# *Owosso Planning Commission*

RE: Special Planning Commission Meeting: February 2, 2016

# SITE PLAN FOR CARGILL ANIMAL NUTRITION PROJECT SPARTAN

**City of Owosso Planning Commission Staff Report**

REV: **C9**  
 SHEET# **9** OF **16**  
 JOB No: 15C0179

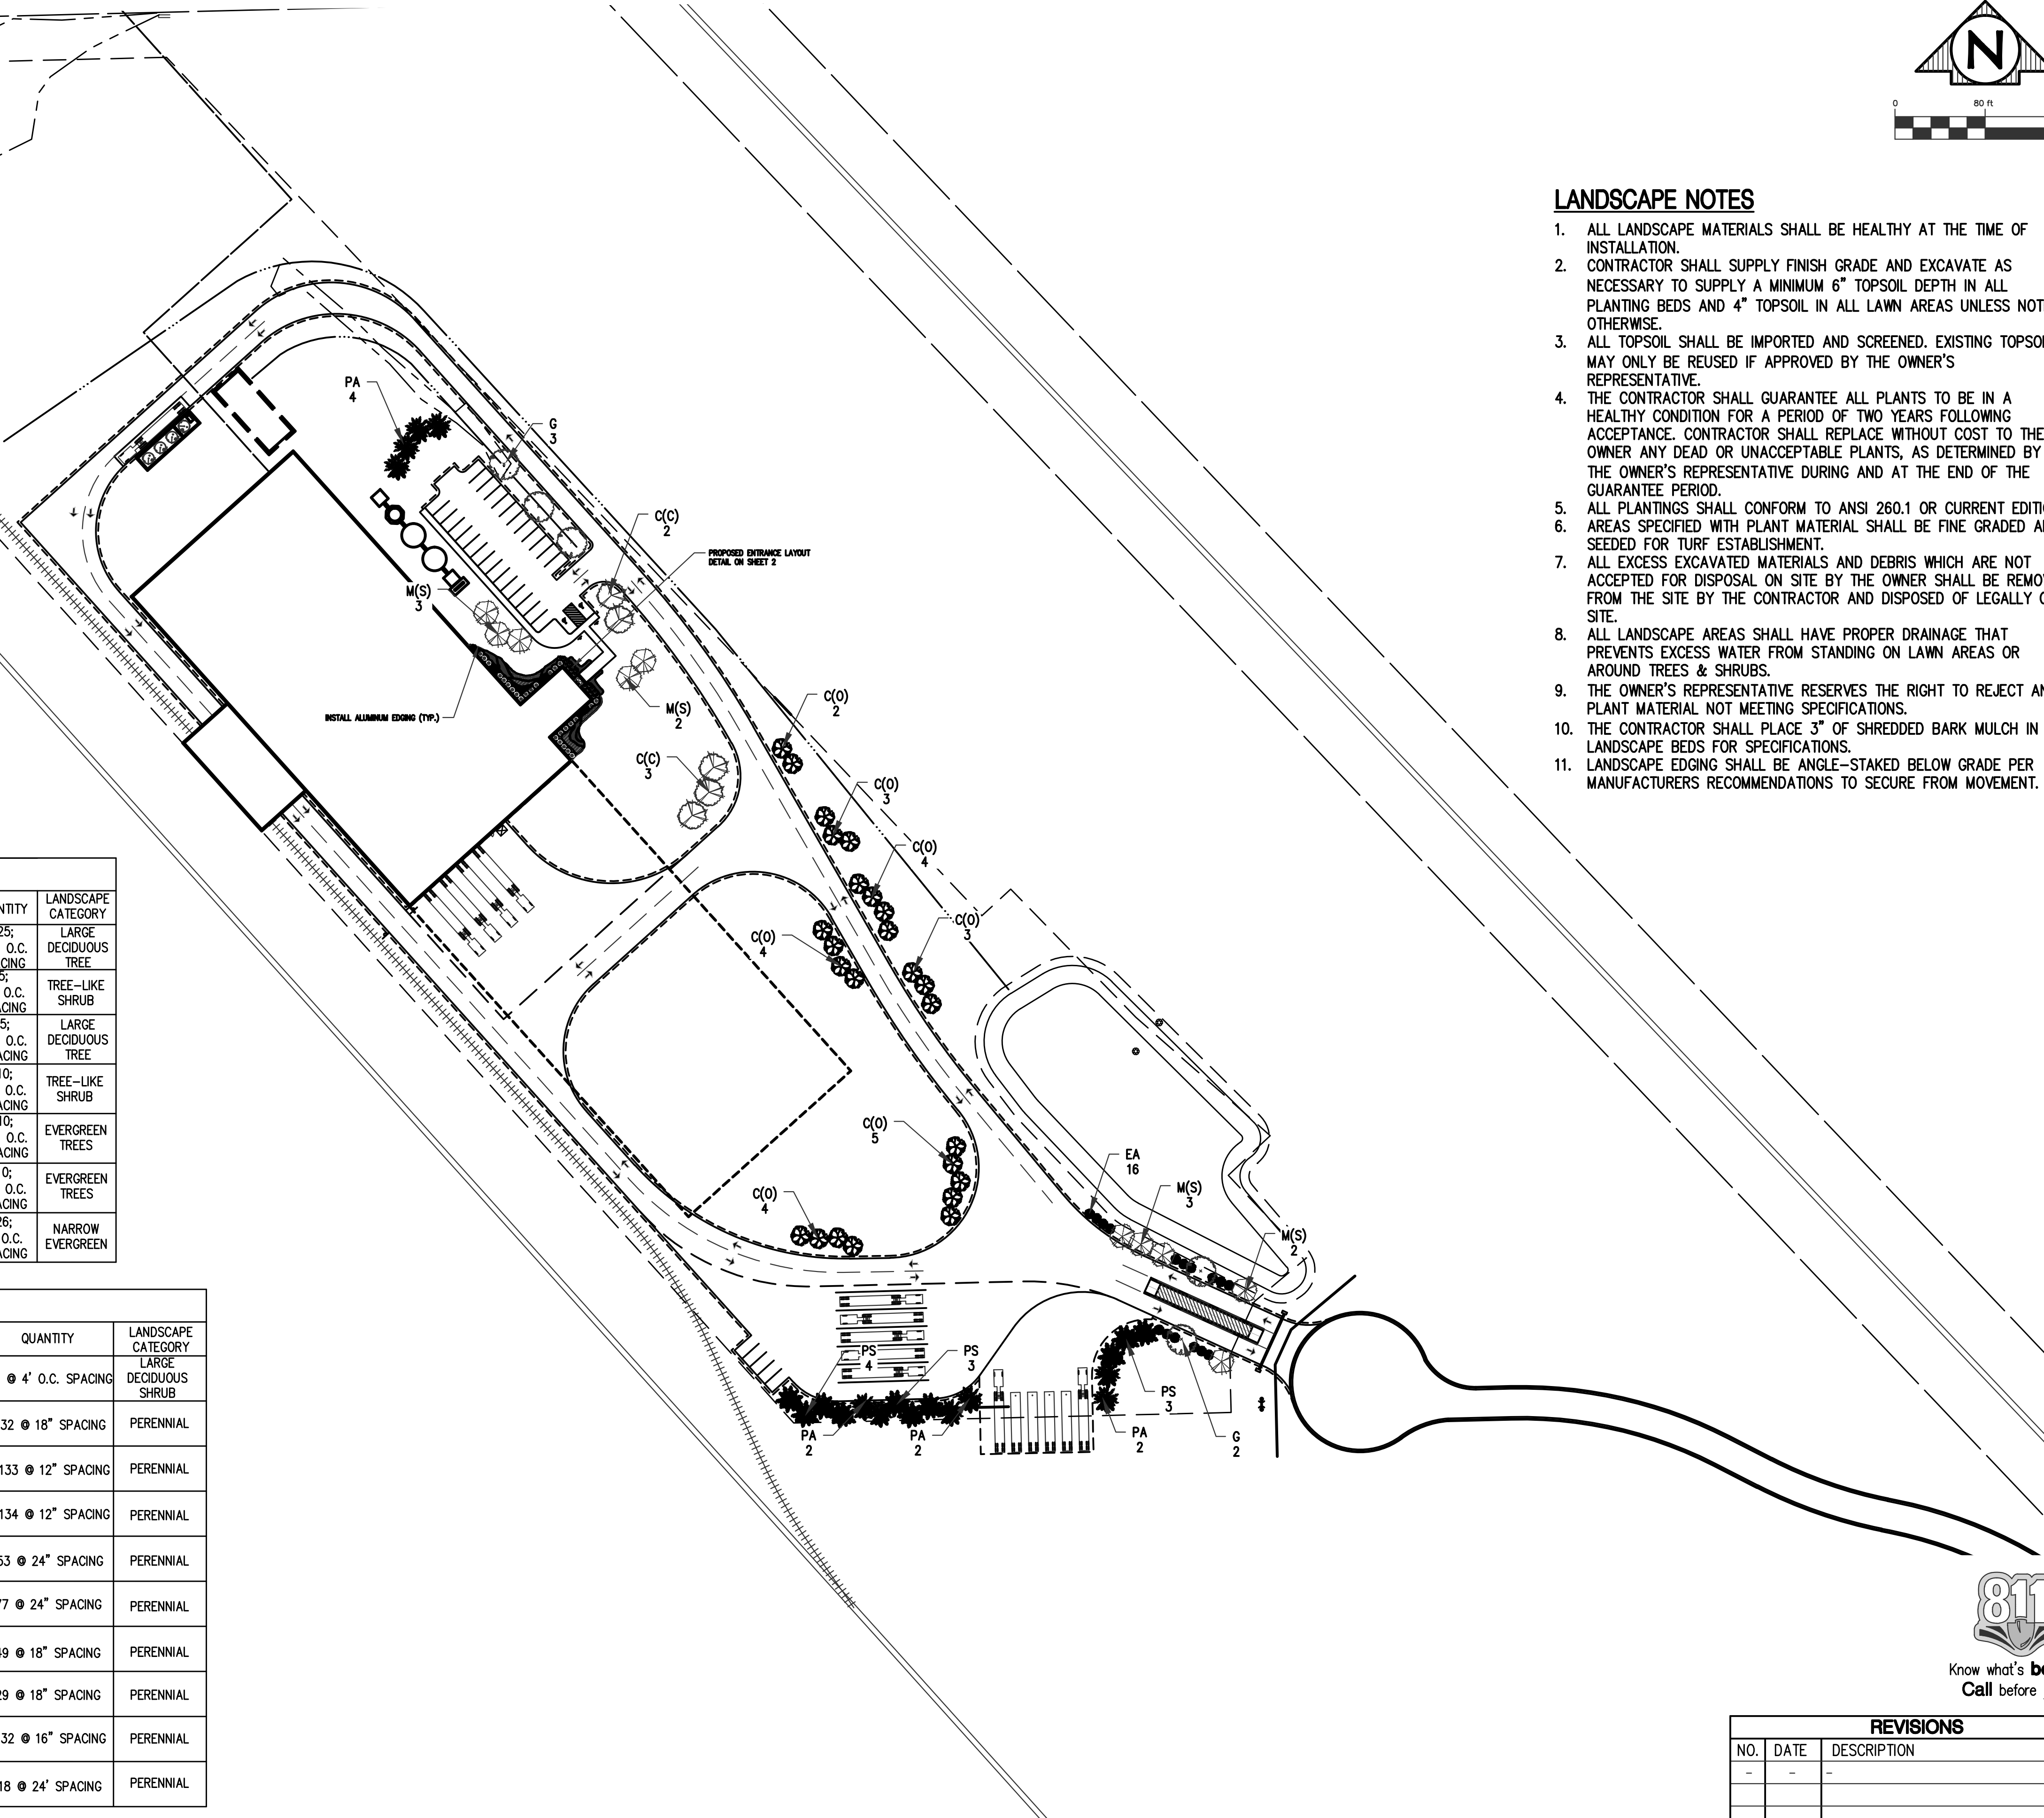
8. Sheet C9, Site Plan:
- a. There is much earthwork involved on site. The volume of work is not clear, but it should be noted whether all or some of the excavated earth must remain somewhere on site. The excavated material may have to be encapsulated.

- e. The storm sewer pipe material is not identified. I recommend SDR 26 plastic pipe. Outlet pipe size is satisfactory.
  - f. The plan note states that a Soil Erosion and Sedimentation Control (SESC) permit will be required, but lists the controlling agency as the county rather than the City. Regardless who will be the permitting agency, the City should have the opportunity to review and comment as to the SESC plan.

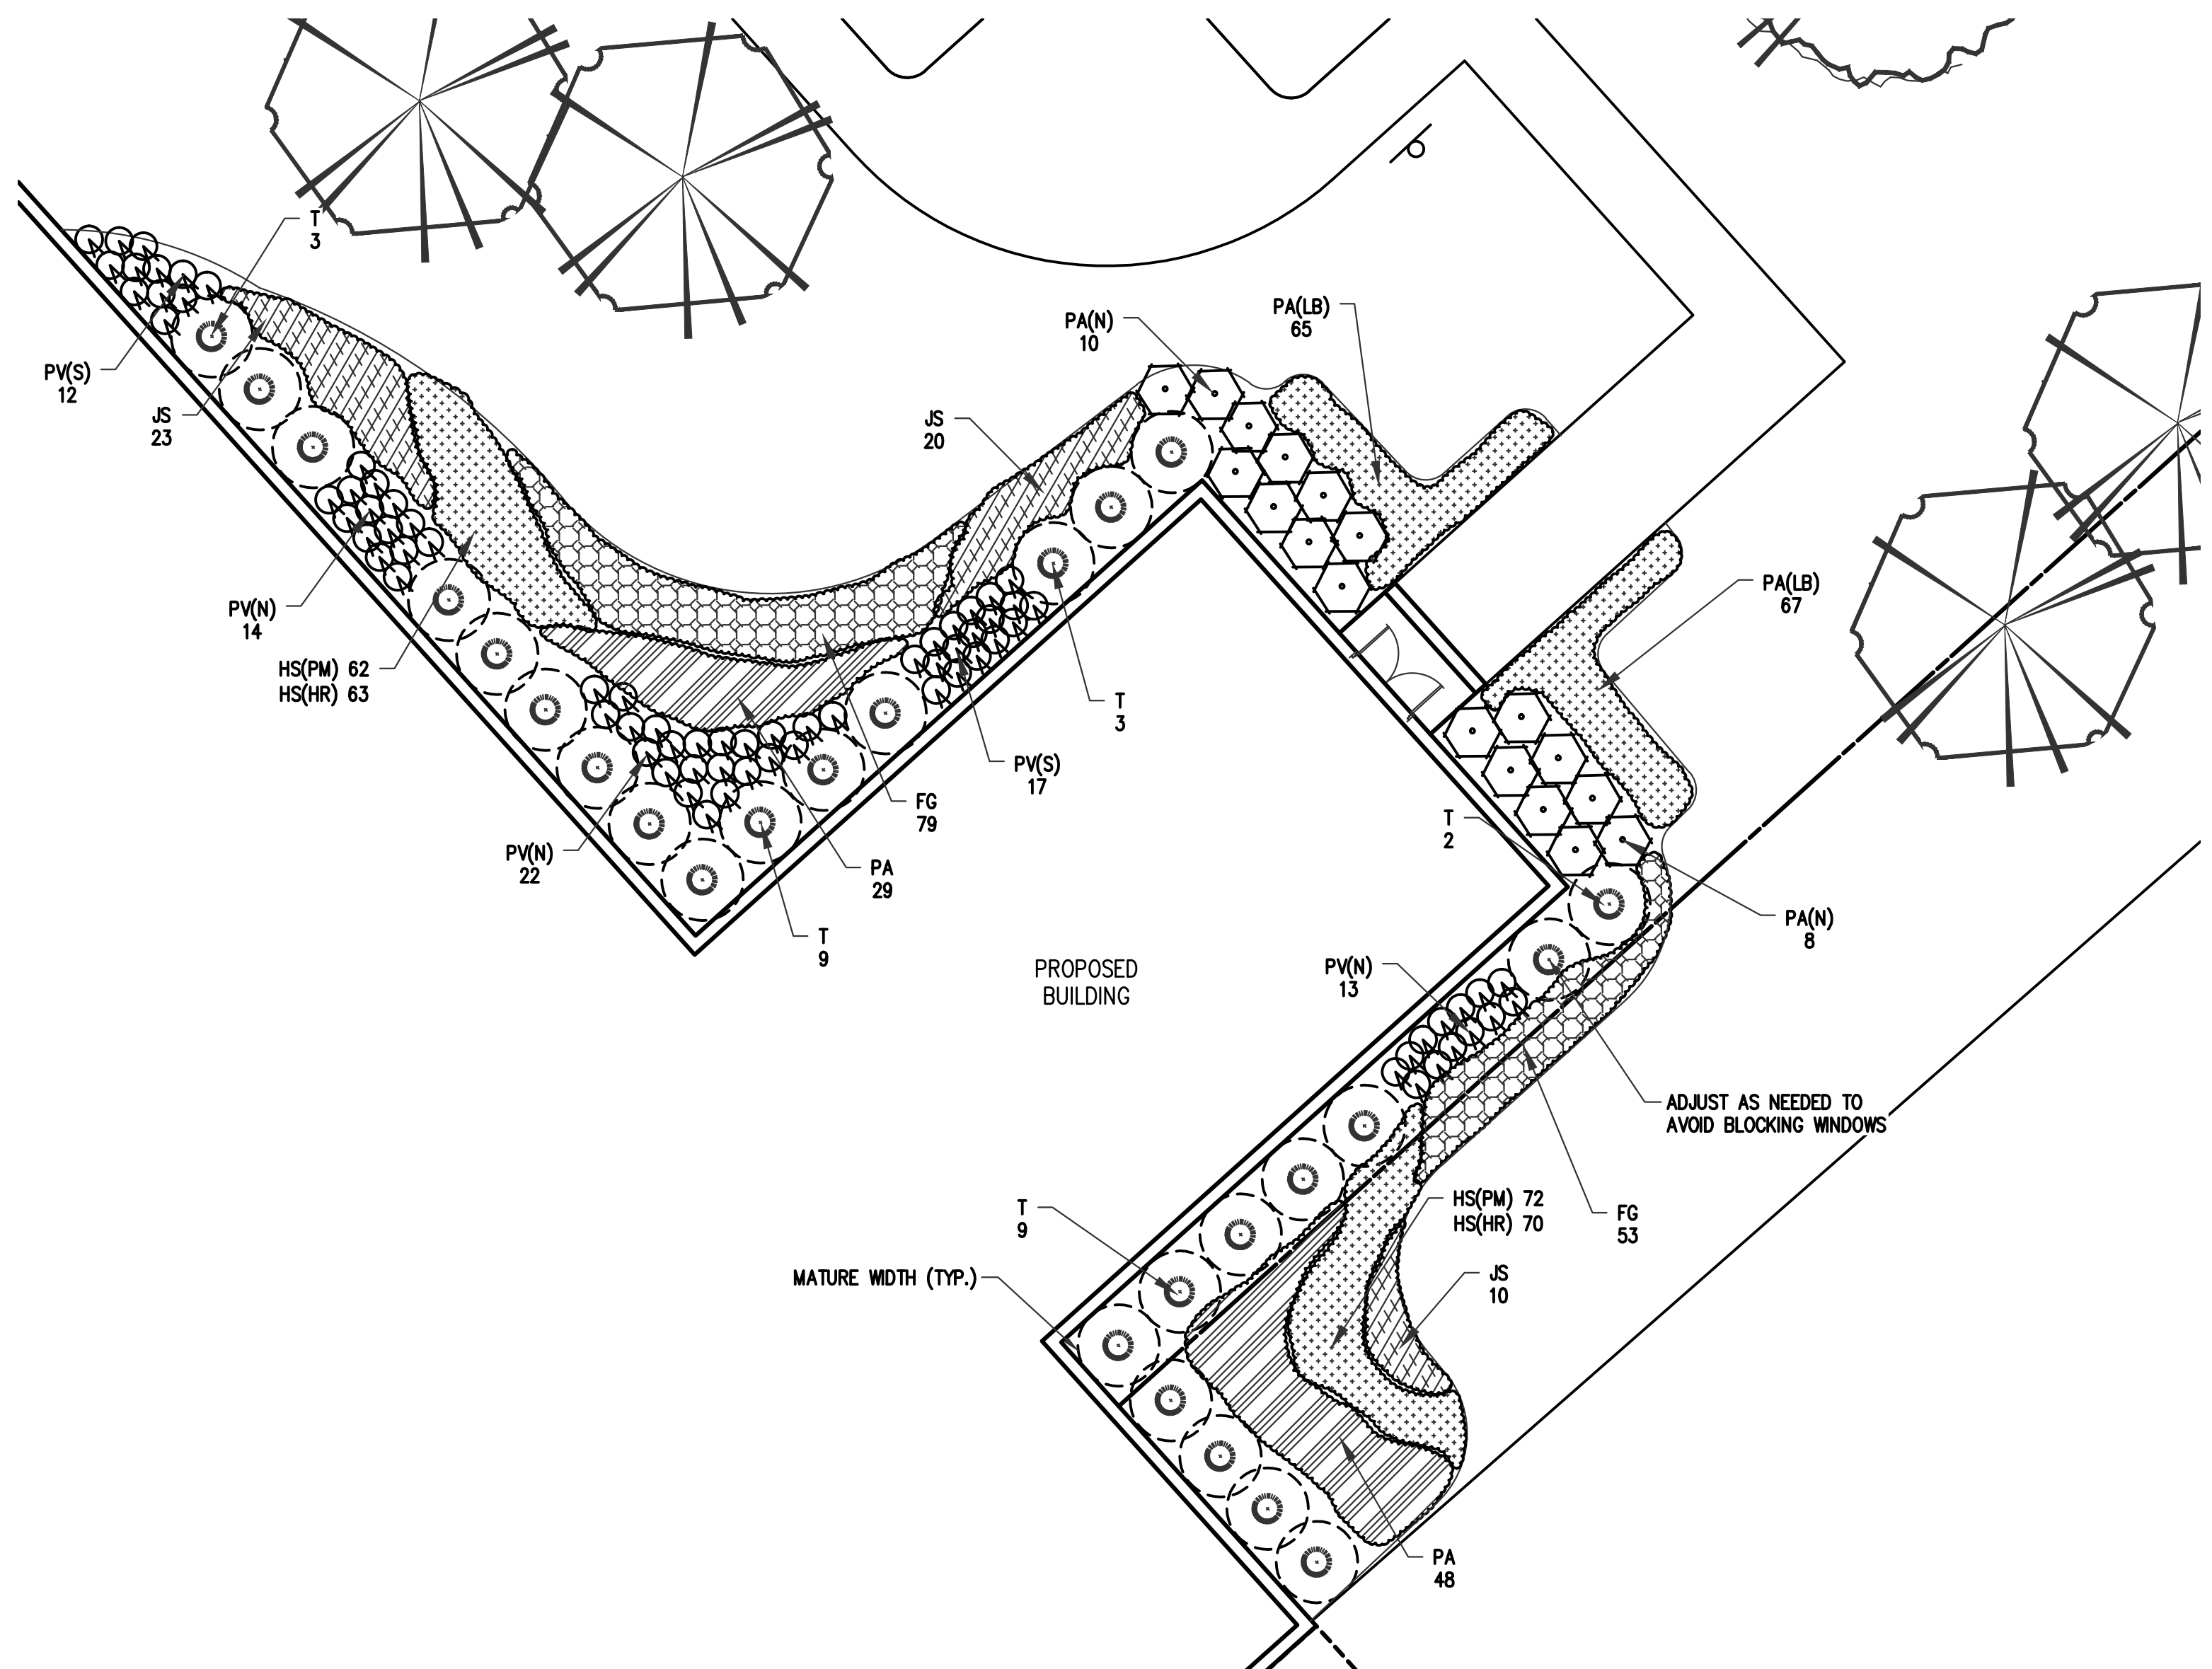
- g. All other notes and details on this page appear satisfactory.
9. Sheet C10, Landscaping Plan:
- a. Plan note 7 discusses removal of all excess excavated material. This note should be reviewed as to whether the excavated material must remain on site.

- b. Tree species is described in the plan. The city's arborist should comment whether the tree species is acceptable.
  - c. All other notes and details on this page appear satisfactory.

TITLE	
		SITE LIGHTING PHOTOMETRICS	
DIVISION/SUBSIDIARY CARGILL ANIMAL NUTRITION		PROJECT	DRAWING NO.
		35 TPH DAIRY FEEDMILL	
PLANT	OWOSSO, MICHIGAN	DATE	11/16/15
SCALE	NOTED

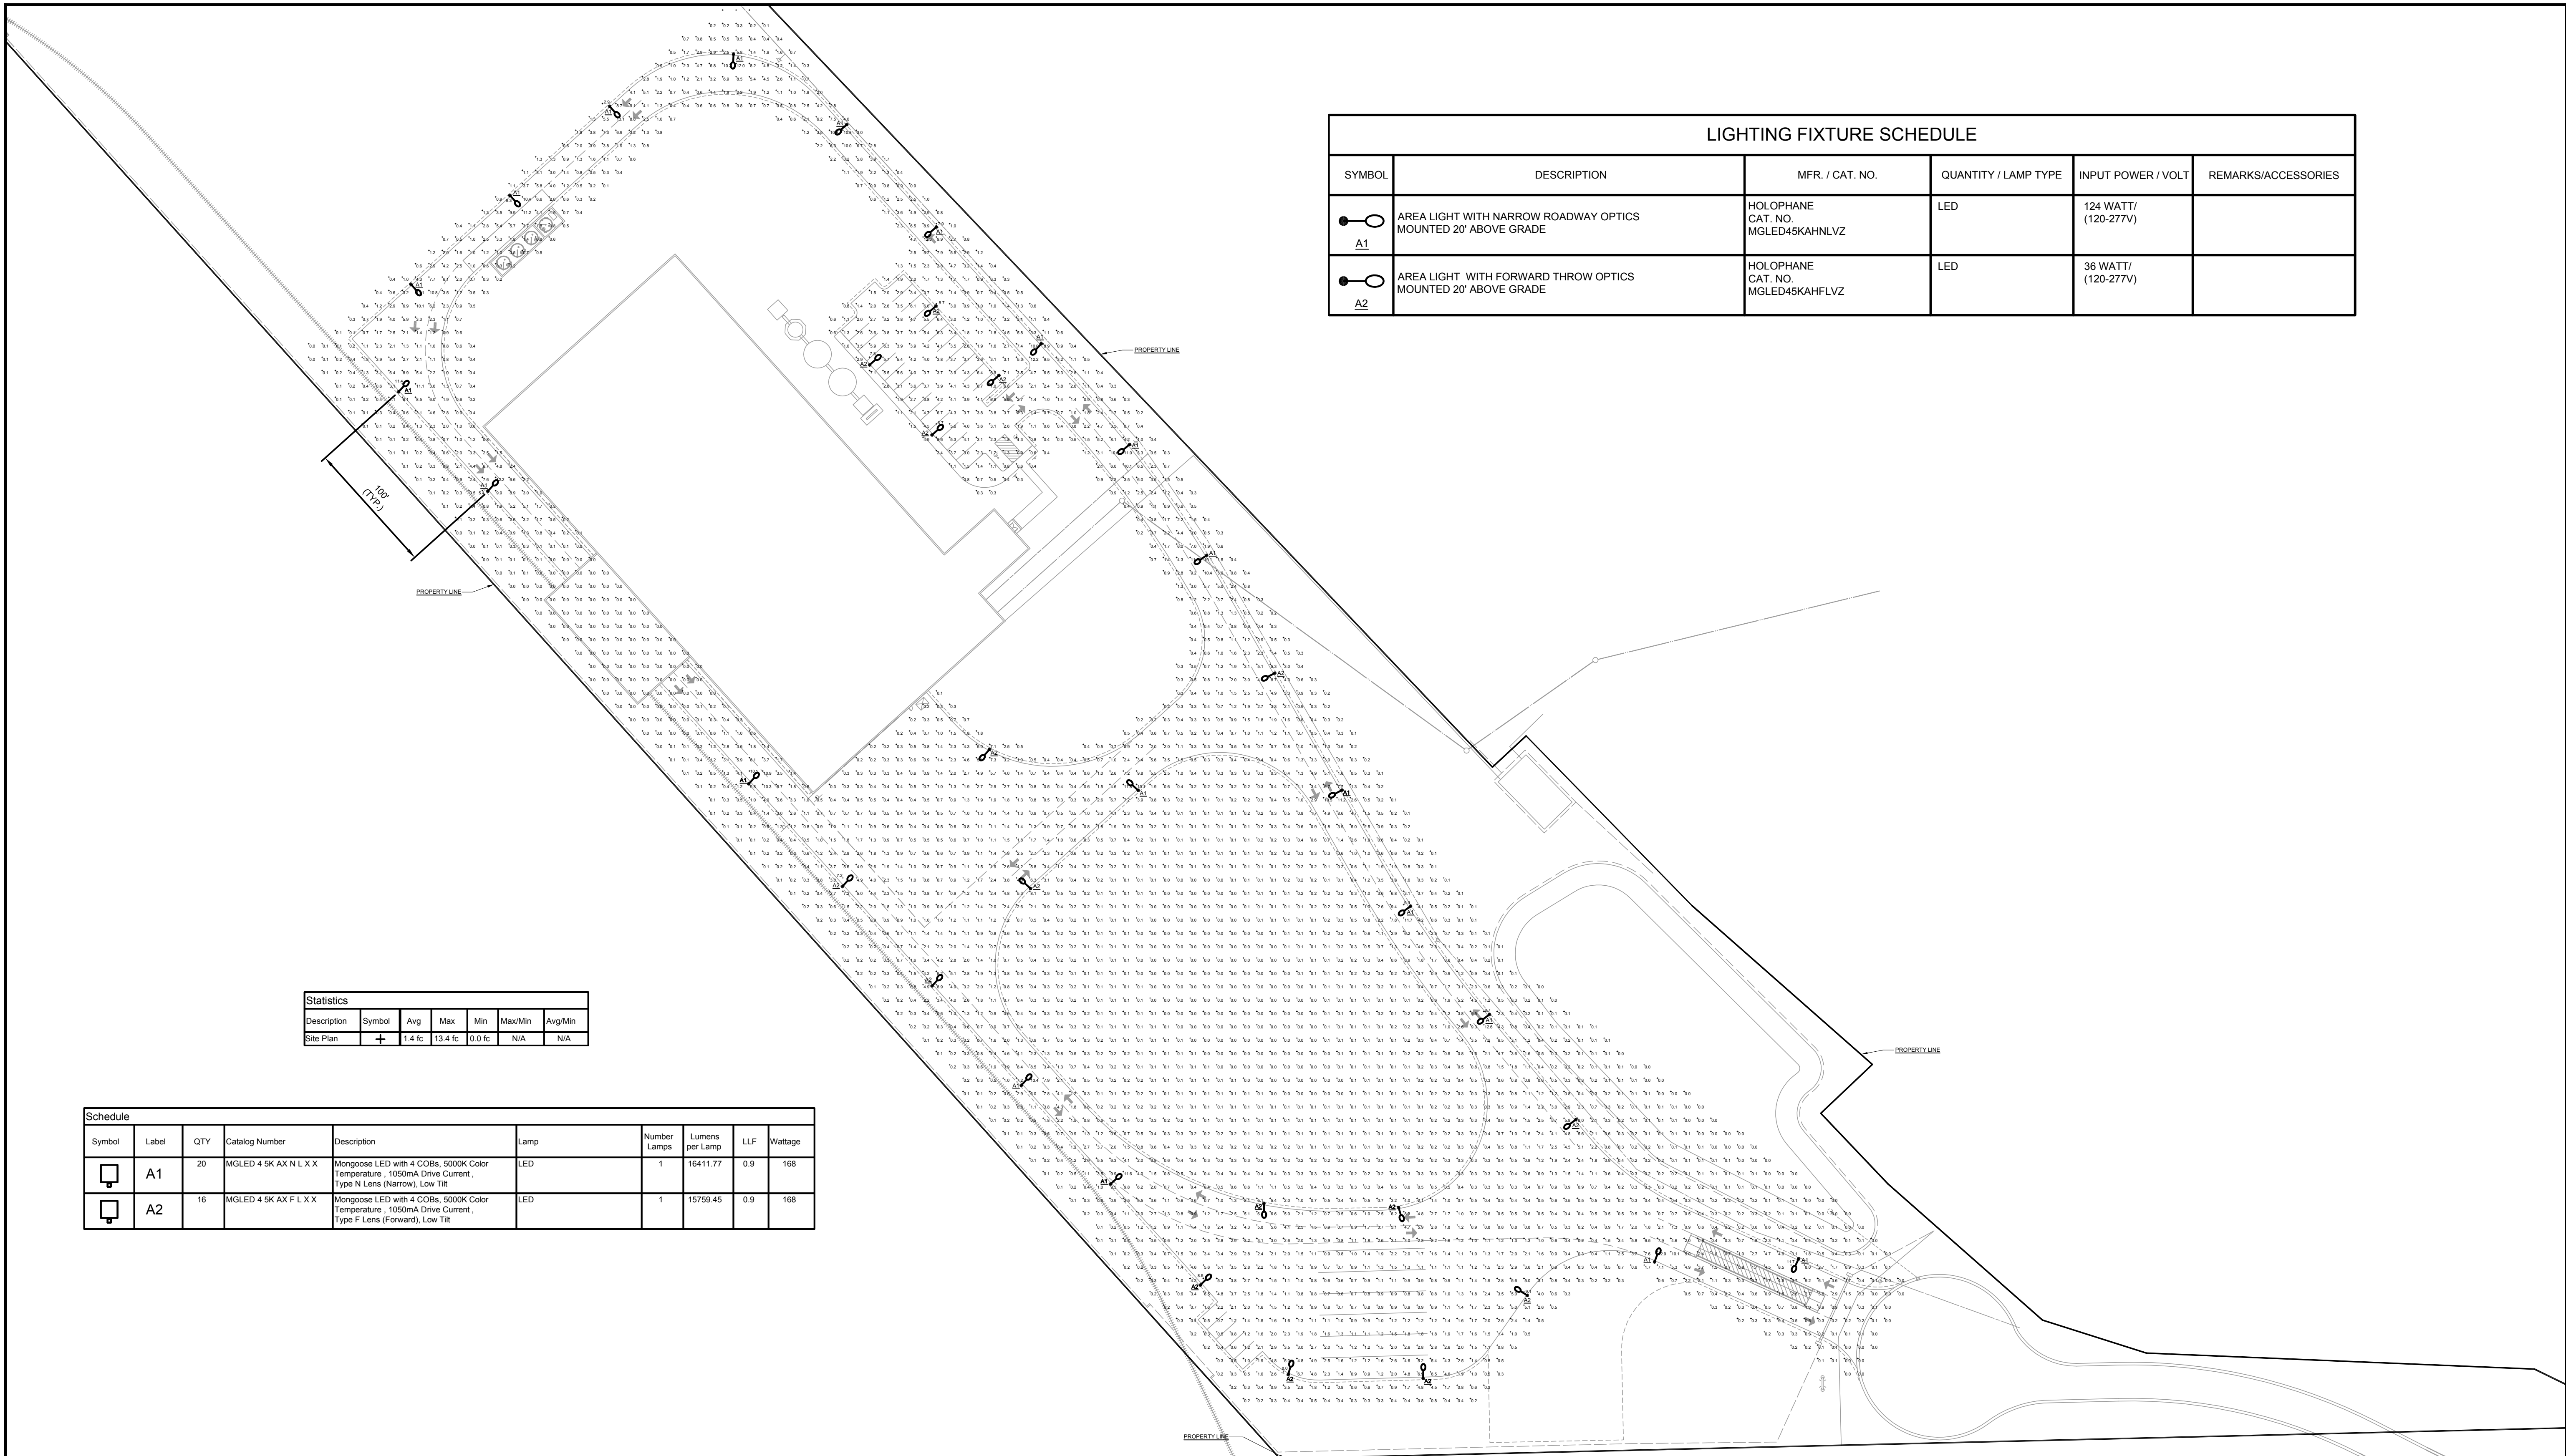
10. Sheets G-Series should be reviewed by the City Building Department.
11. Sheet ELP1 Lighting Plan:
- a. The lighting plan calls for a combination of 124 Watt and 36 Watt lights mounted at 20' height above ground, and spaced at 100-feet. This amount of lighting should provide an
